ADDENDUM #3

PREBID MEETING AGENDA Newton Church of the Way 6/10/25, 3:30 PM

The Work of this Project is described as the construction of a new 9,632 square foot multi-purpose facility for The Newton Church of the Way, located at 2306 South 3rd Ave, Newton, Iowa.

EXTERIOR ELEVATIONS

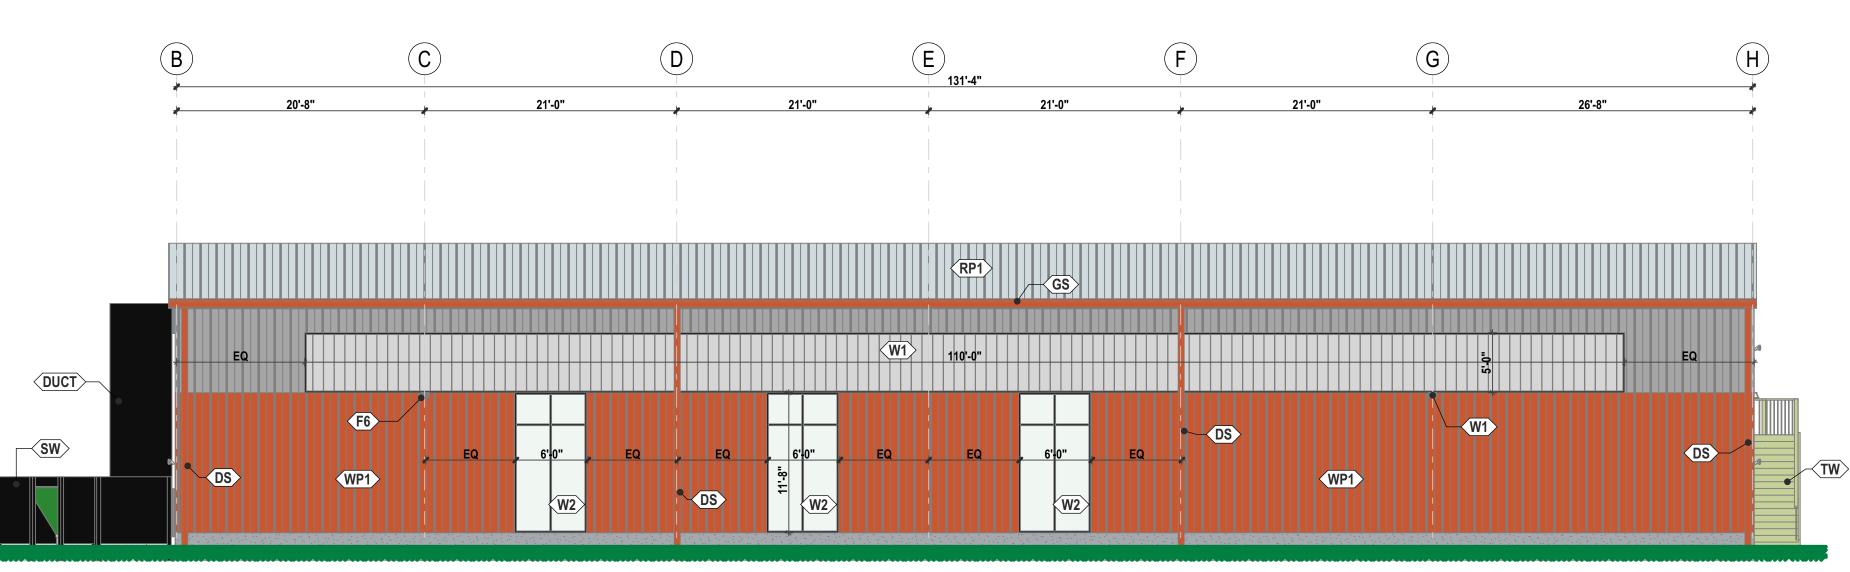
- A. Specification Section 08 80 00 Glazing (not reissued).
 - 1. Paragraph 3.2, A, 3; Revise as:
 - a. Swinging doors storefront:
 - 1) U value: 0.37
 - 2) SHGC: 0.40
 - b. Storefront window systems:
 - 1) U value: 0.26
 - 2) SHGC: 0.30
- B. Specification Section 20 00 00 Mechanical (not reissued).
 - 1. Paragraph 2.2, A; Revise as:
 - a. RTU units shall be gas/electric.

TW ALL DOORS AND GLAZING SYSTEM SHALL COMPLY WITH THE FOLLOWING: DOORS SWINGING STOREFRONT: U VALUE: 0.37
SHGC: 0.40
FIXED WINDOWS / STOREFRONT / POLYCARBONATE PANELS:

U VALUE: 0.26 SHGC: 0.30
